STAFF REPORT

Review of City of Palo Alto Utilities' 2023 Integrated Resource Plan

October 2025 | CEC-200-2025-028

Figure 2: CPAU's Total Net Energy for Load and Total Peak Procurement Requirement: 2024-2030

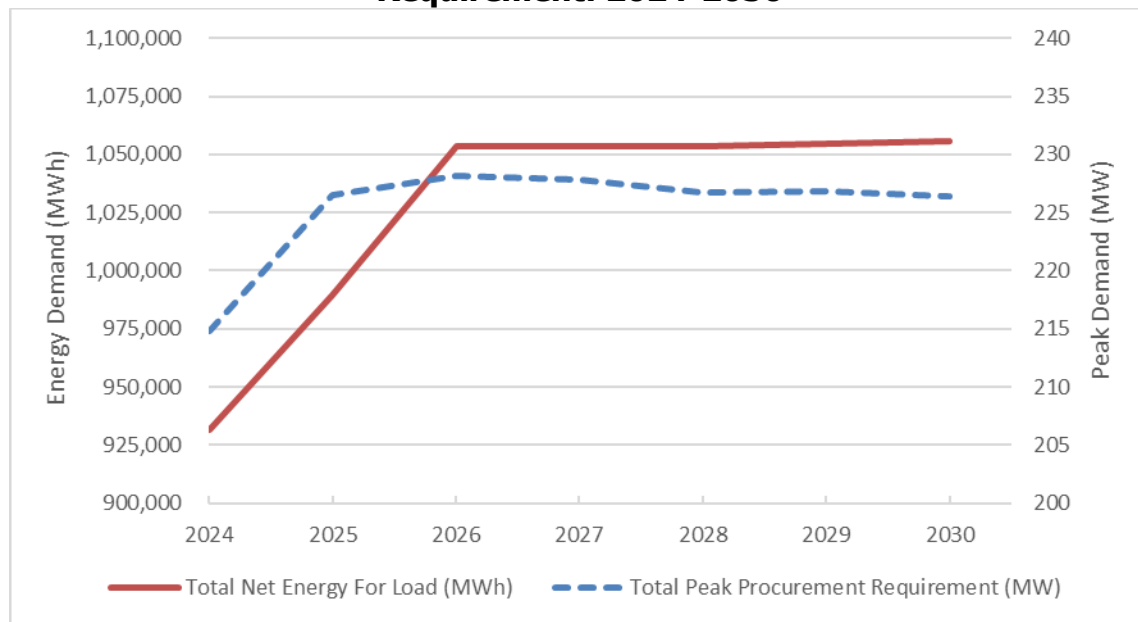
CPAU's monthly energy demand is relatively flat in 2025, with February being the month with the highest amount of consumption, followed by August, while April has the lowest. While monthly energy demand is estimated to increase by 2035, this monthly ranking order does not change. This energy demand profile has implications for resource procurement and utility operation, which are discussed further in the Procurement Strategy section.

CPAU's energy forecast starts higher than the CEC's energy demand forecast, increasing to 17 percent higher in 2026, before ending 4.5 percent lower than the CEC's energy demand forecast in 2030. CPAU's peak demand follows a similar trend, starting higher than the CEC's peak demand forecast, increasing to 19 percent higher in 2025, before decreasing and ending 7 percent lower than the CEC's peak demand forecast in 2030. These differences are caused

by the large increase in CPAU's near-term forecast followed by a leveling off in both energy and peak demand increases, while the CEC forecast projects a more gradual and steady increase in energy and peak demand through 2030.

CPAU's forecast includes variables such as energy efficiency, rooftop solar, EV adoption, and building electrification. Based on staff's review, CPAU's energy and peak demand forecast appears suitable for long-term planning.
